PPR 2248

STRUTHERS RANCH POLARIS
847 STRUTHERS RANCH ROAD
LOTS 1-2, STRUTHERS RANCH SUB. FIL. NO. 4
EL PASO COUNTY

NOT FOR CONSTRUCTION	JOB NUMBER	1088-22
	REVISIONS	
	11-23-22	PER COMMENTS
	2-21-23	PER COMMENTS
ORIGINAL DATE	J. MACKAY	
DRAWN BY	8-15-22	
DESCRIPTION	FINAL LANDSCAPE PLAN - AREA A	
SHEET NO.	L1.1

LANDSCAPE PLAN AREA A

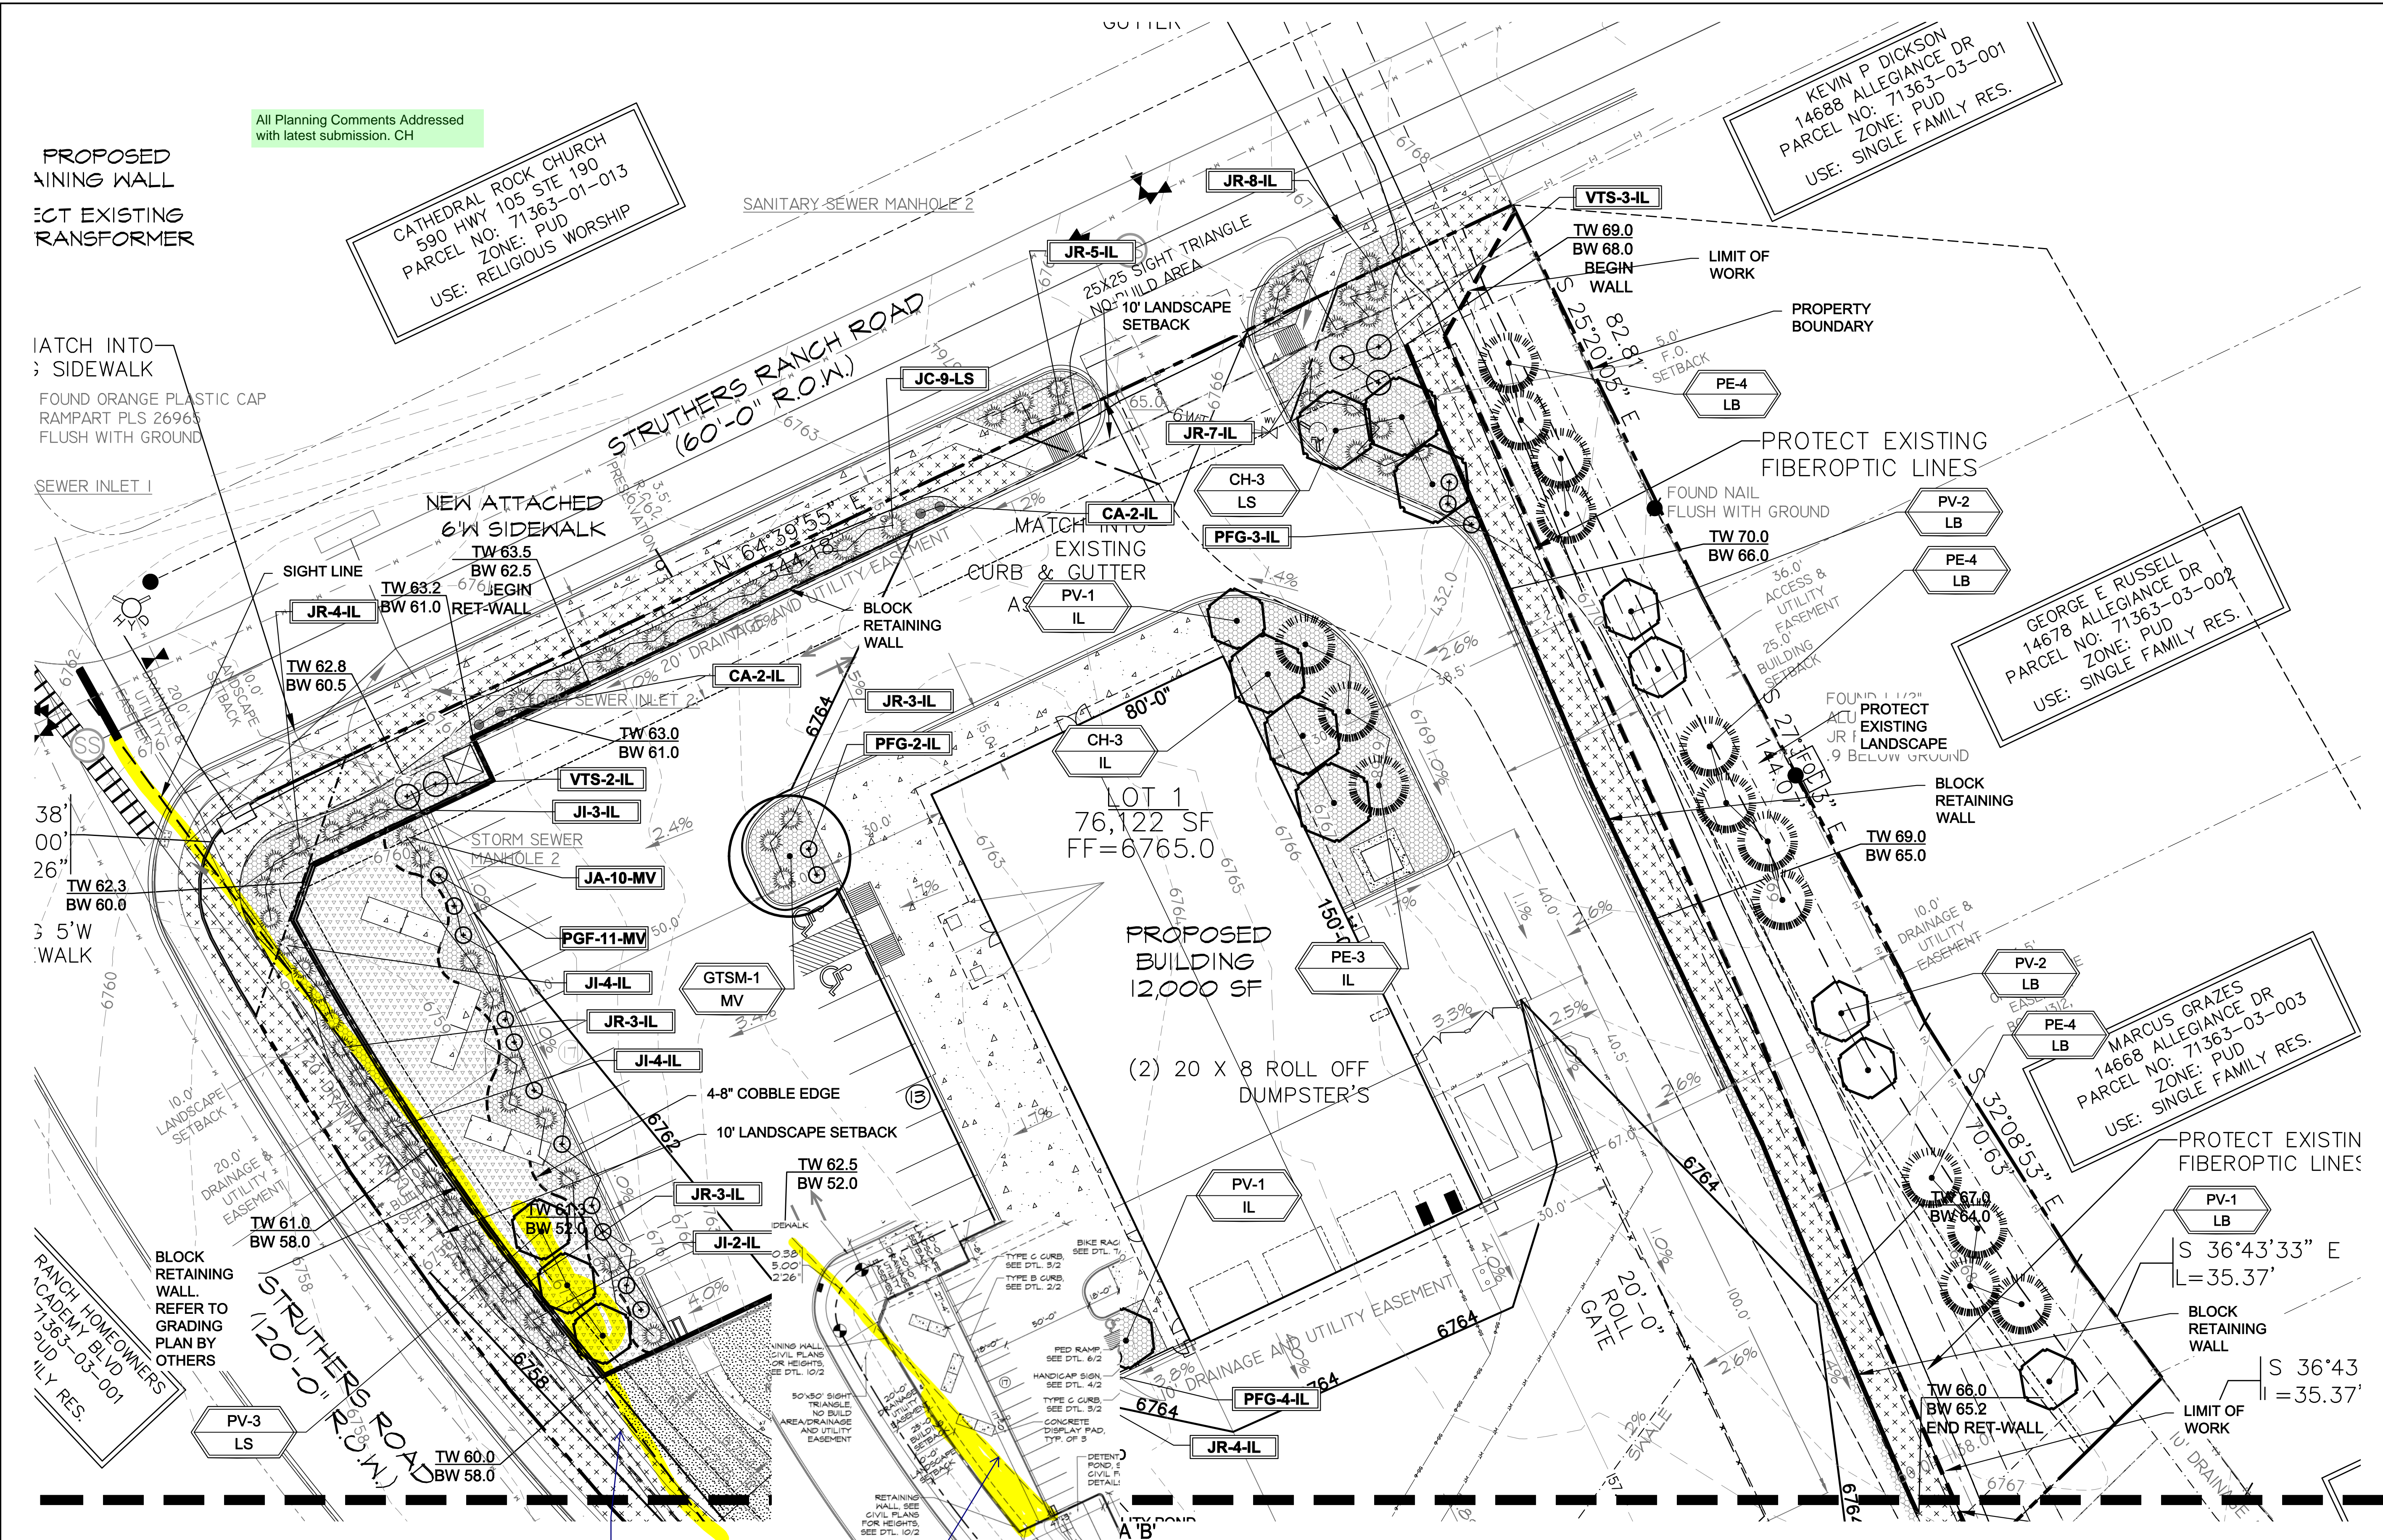
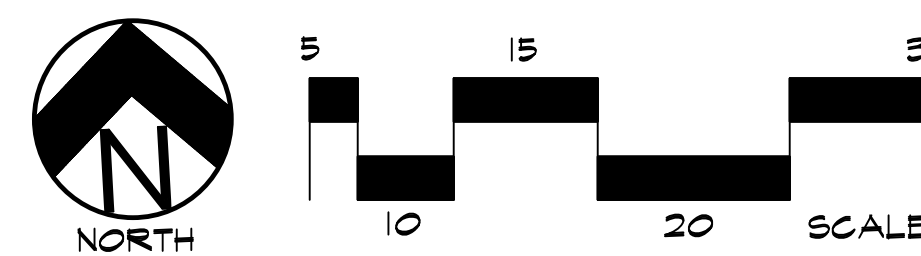
Review #2: The line of sight shown on the landscape plan is incorrect. Per the TIS the required line of sight is 590 ft while the current landscape plan is showing 354 ft. Coordinate with the Traffic Engineer and Civil Engineer for the line of sight layout. Keep in mind that within the sight triangle objects must be less than 30 inches relative to the flowline elevation of the adjacent roadway.

Review #3: Unresolved. Update the line of sight to match the site plan. Based on the site plan the three deciduous trees appears to be located in the sight triangle and must be relocated.

NOT FOR CONSTRUCTION	JOB NUMBER	1088-22
	REVISIONS	
	11-23-22	PER COMMENTS
	2-21-23	PER COMMENTS
ORIGINAL DATE	J. MACKAY	
DRAWN BY	8-15-22	
DESCRIPTION	FINAL LANDSCAPE PLAN - AREA B	
SHEET NO.	L1.2

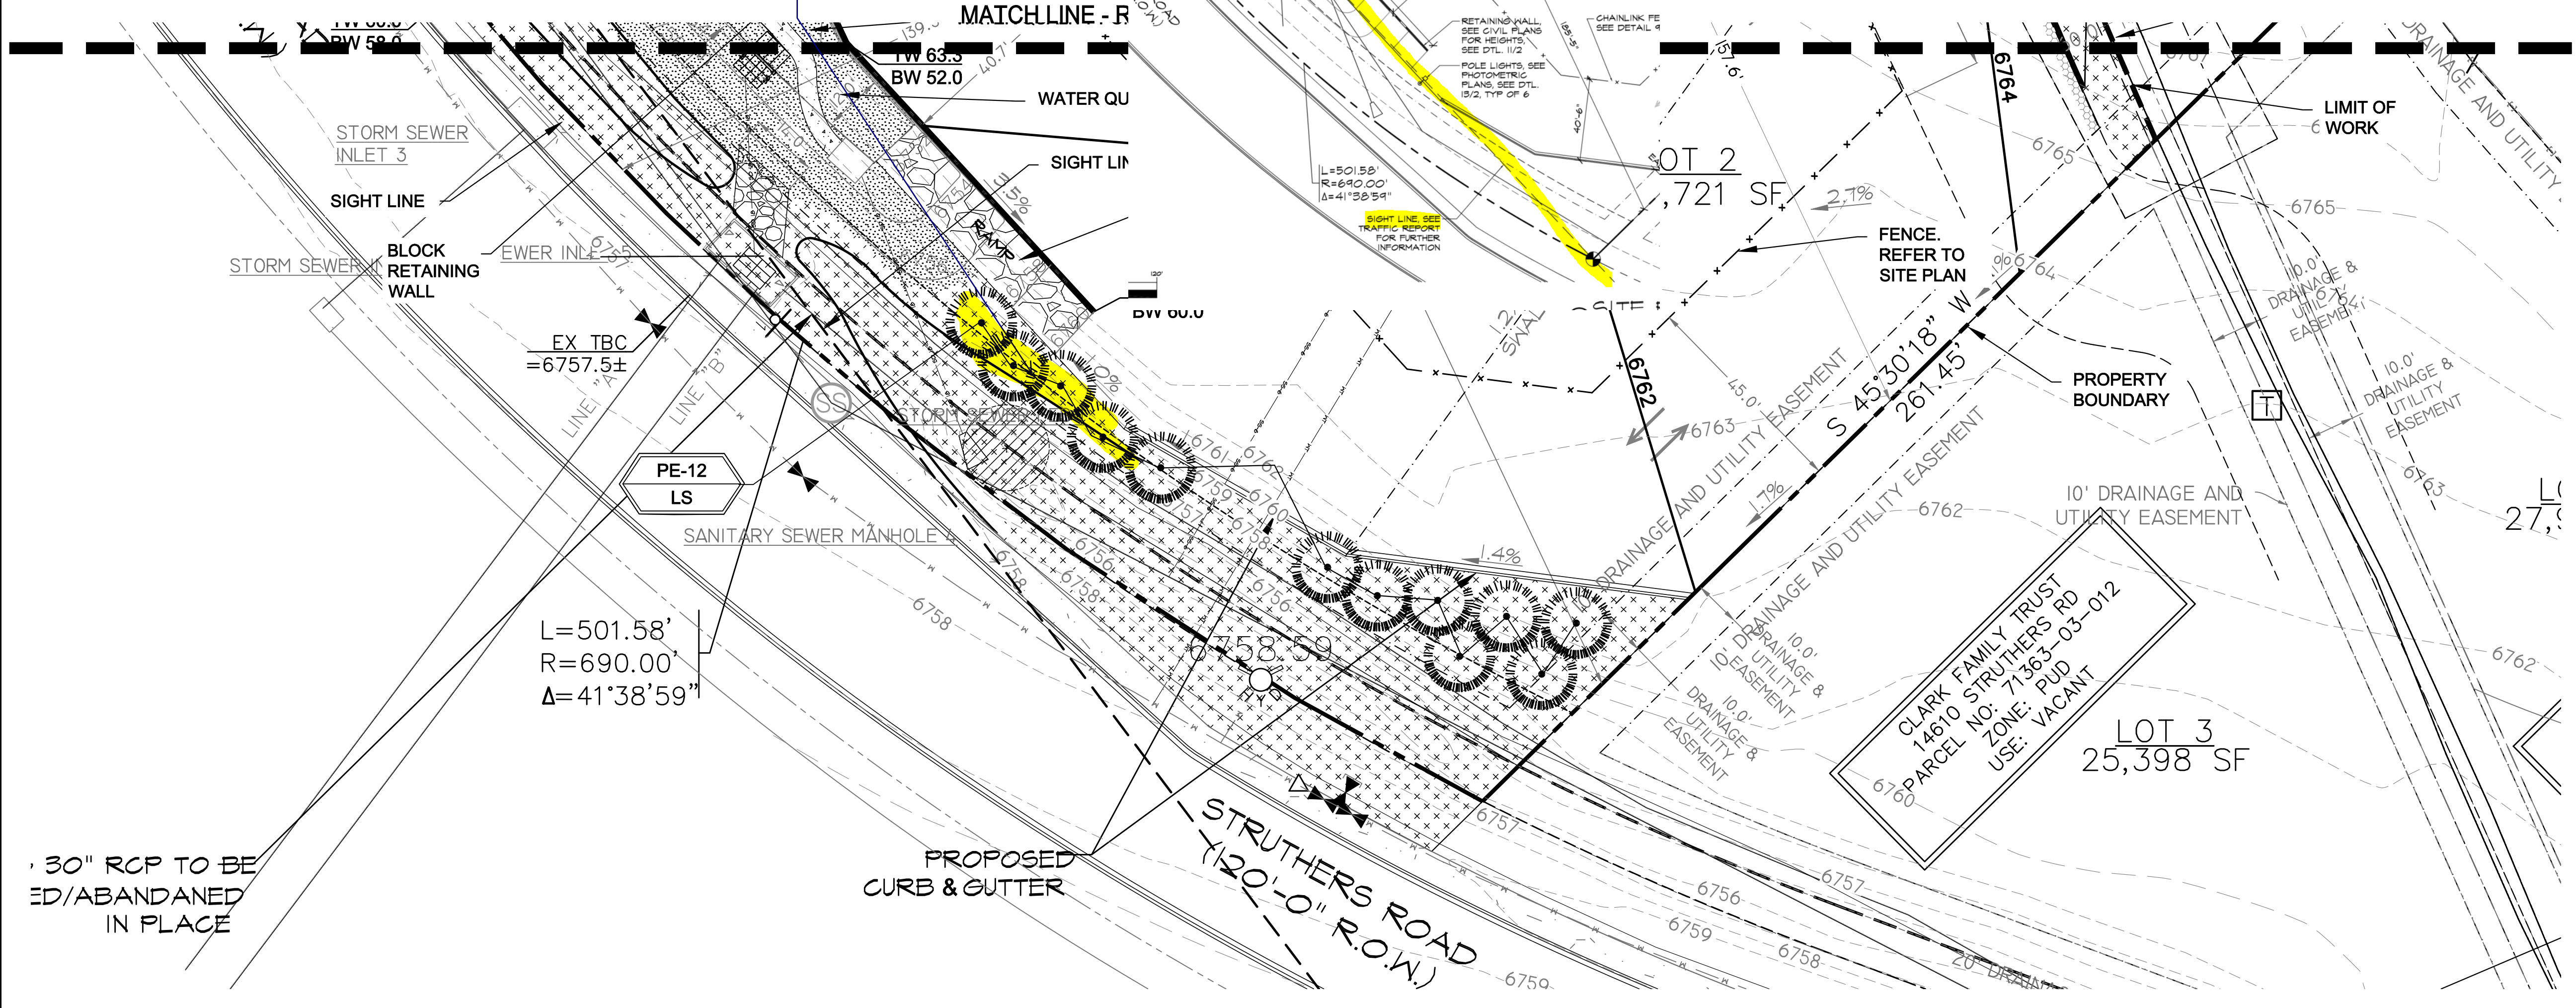
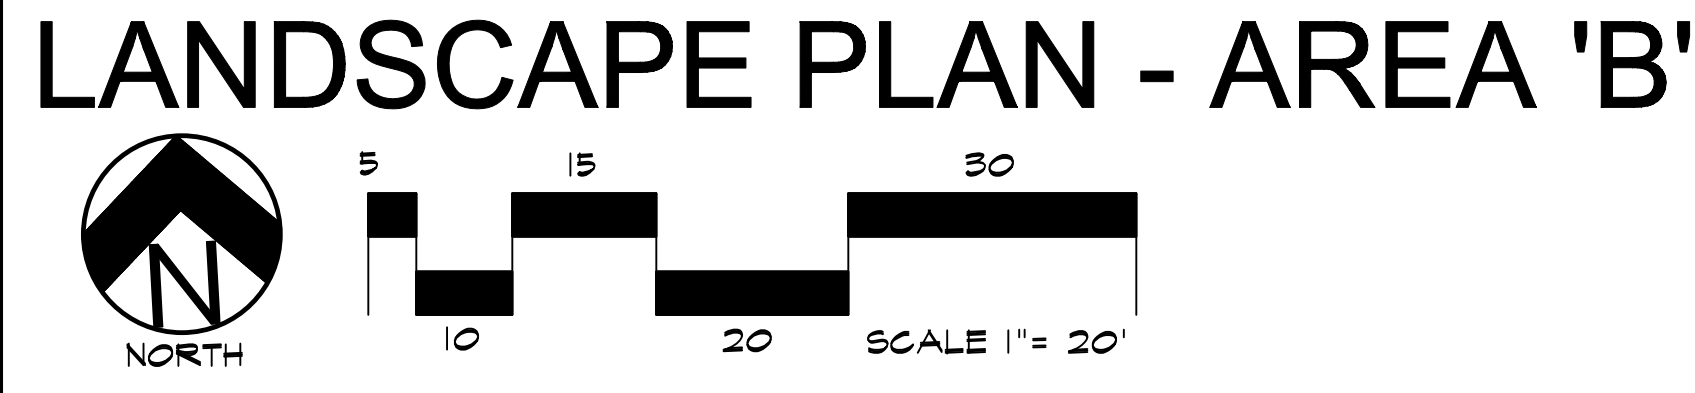
Review #2: The line of sight shown on the landscape plan is incorrect. Per the TIS the required line of sight is 590 ft while the current landscape plan is showing 354 ft. Coordinate with the Traffic Engineer and Civil Engineer for the line of sight layout. Keep in mind that within the sight triangle objects must be less than 30 inches relative to the flowline elevation of the adjacent roadway.

Review #3: Unresolved. Update the line of sight to match the site plan. Based on the site plan the evergreen trees appear to be located in the sight triangle and must be relocated.
